NSD-NRC-96-4913  
DCP/NRC0683  
Docket No.: STN-52-003

SUBJECT: AP600 RESPONSE TO REQUESTS FOR ADDITIONAL INFORMATION

Enclosure 1 provides Westinghouse responses to NRC requests for additional information pertaining to the in-vessel retention (IVR) of molten core debris. Specifically, the responses to RAIs 480.440 through 440.461 are included in this enclosure. The RAIs were transmitted to Westinghouse in a NRC letter dated November 7, 1996.

Fig. 11. The heat flux distribution along the lower boundary in ACOPO Run 5/28/96 compared with the correlation obtained from mini-ACOPO. Data shown only every 600 s (for clarity), for the duration of the run.

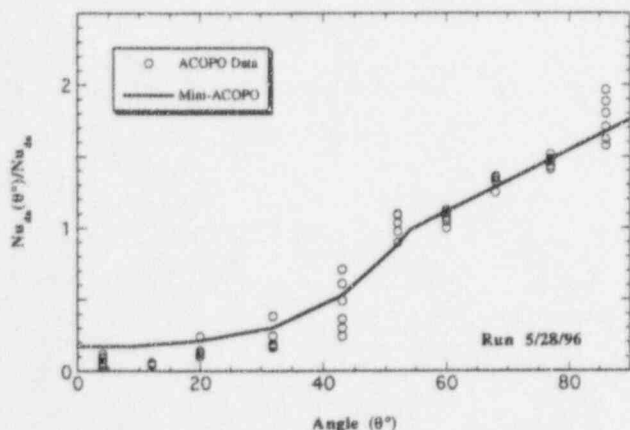
For example, take Figure 11 of Attachment 480.444-1. Data can be found that exceeds the correlation by approximately 40 percent. Using this in Figure 7.10, the  $q(\theta)/q_{CHF}$  increases from 0.4 to 0.56. That is a local reduction in margin from 250% to 180%.
